ATTACHMENT 1

TECHNICAL SPECIFICATION CHANGES

(MARKED-UP)

SAFETY EVALUATION FOR THE
CALLAWAY PLANT MSFIS MODIFICATION
AND TECHNICAL SPECIFICATION AMENDMENT

FIGURE 1
 MSIV and FIV Valves
 Current System

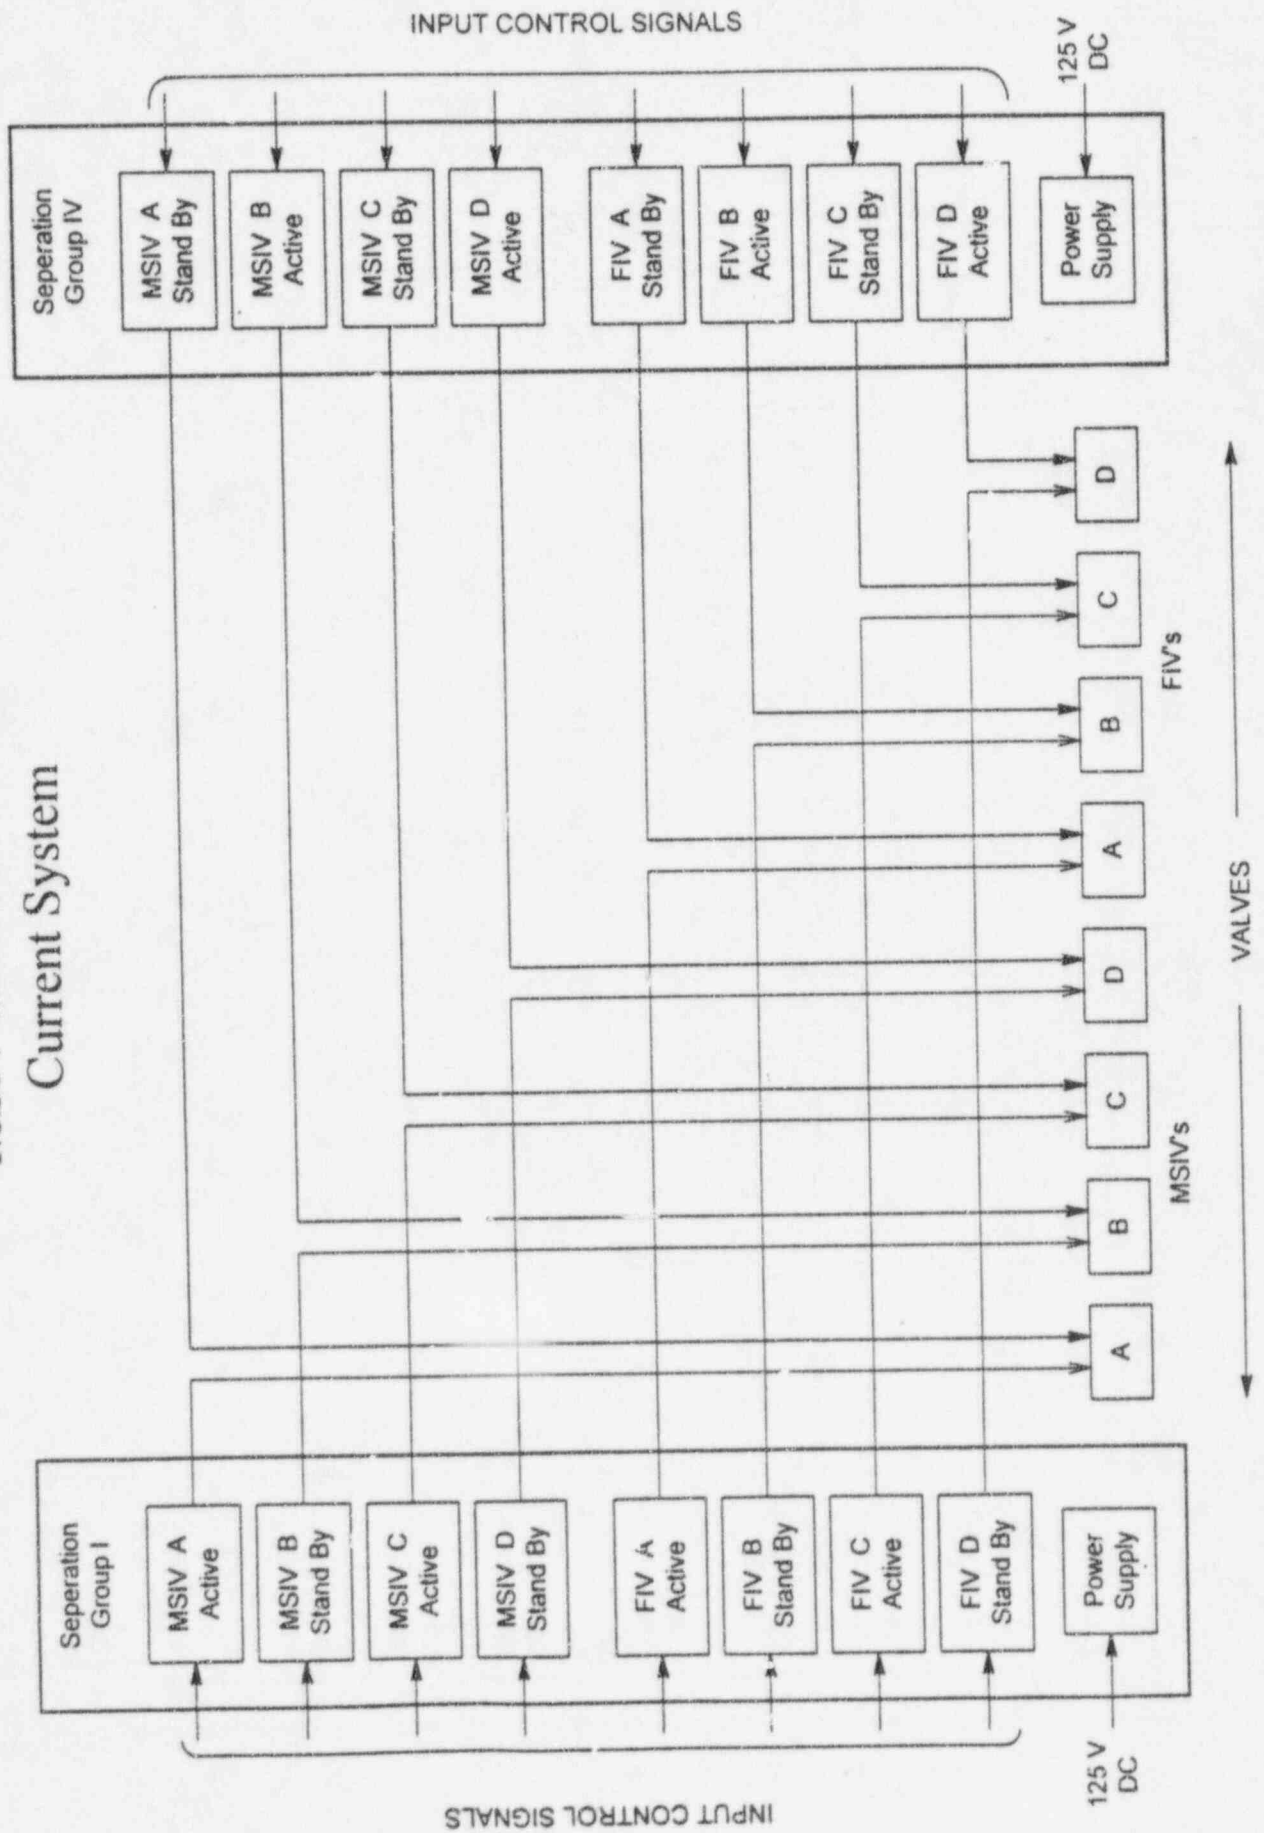
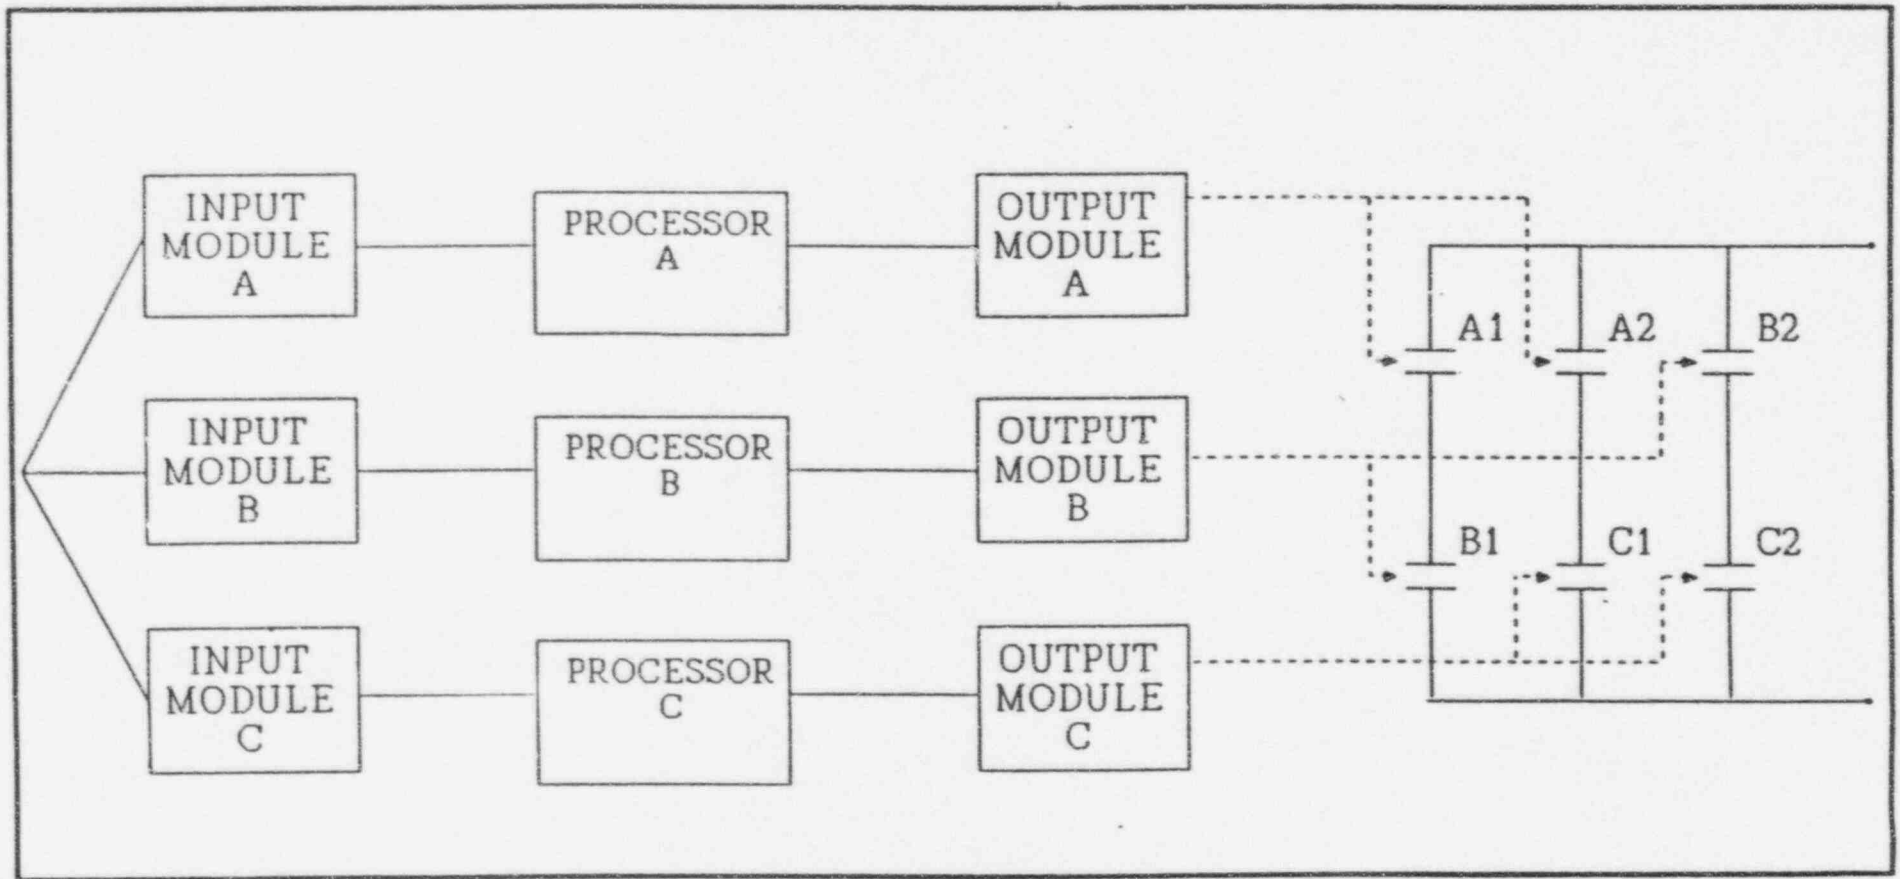
The system is composed of triple redundant logic consisting of three logic channels in two different trains or separation groups. The triple redundant logic will provide the MSFIS equipment with a 2 out of 3 voting scheme (see Figure 2). The output module contacts for each logic channel are normally open and close to trip. The 2 out of 3 voting scheme solves the problem of a 1 out of 2 nuisance actuation. To trigger an actuation, two logic channels (i.e., A-B, A-C, or B-C) per train trip and energize the actuation relays. Each train of MSFIS contains 3 PLCs, one for each logic channel. This logic design requires coincidence testing to ensure each set of combinations can produce an actuation. The 2 out of 3 logic design increases

plant reliability and availability. A single failure cannot trigger a false actuation, nor prevent a true actuation from occurring. If one logic channel fails, the affected train reverts to a 2 out of 2 logic. If a PLC channel failure occurs, a Channel Failure light will energize on the MSFIS test panel and the MCB annunciation of the Channel Failure will occur. This is discussed further in Section 3 of this evaluation. UE performed a Probability Risk Assessment that evaluated this logic scheme. This assessment showed that decreased risk of spurious actuation results in decreased risk of transient induced trips plant trips.
